Cobra Motorcycle Mfg.

TSB0505: King airfilter upgrade with necessary airbox modifications

June 15, 2005

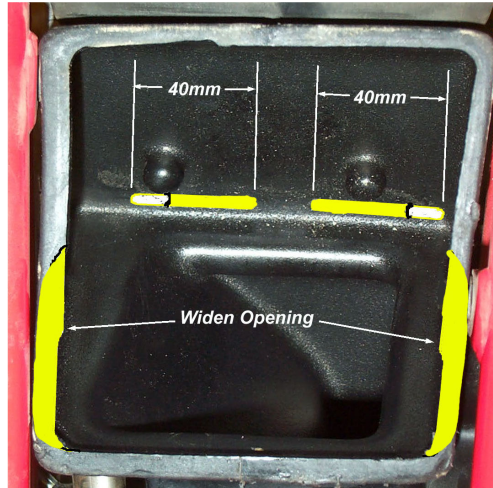
There is an upgrade to the 2005 king air filter and associated modifications to the air box to due to 1) material incompatibility between the King air filter and certain cleaning fluids, and 2) the easy installation and removal of the more rigid air filter in the current airbox.

Old and new style filters are shown below. The new style uses the same wire retainer as the old style.

Old Style

New Style

As the body of the new style air filter is more rigid, the opening in the top of the airbox must be opened a bit to allow easy in/out action. Also, the bottom slots must be opened towards the center as well. See picture below and remove material colored in yellow.

Do not increase the slots entirely across into one single slot as the wire retainer will not have a surface to rest upon.

Increase the two slots in the bottom of the airbox inward for a new width of 40mm (1 5/8") from an initial width of 15mm (5/8")
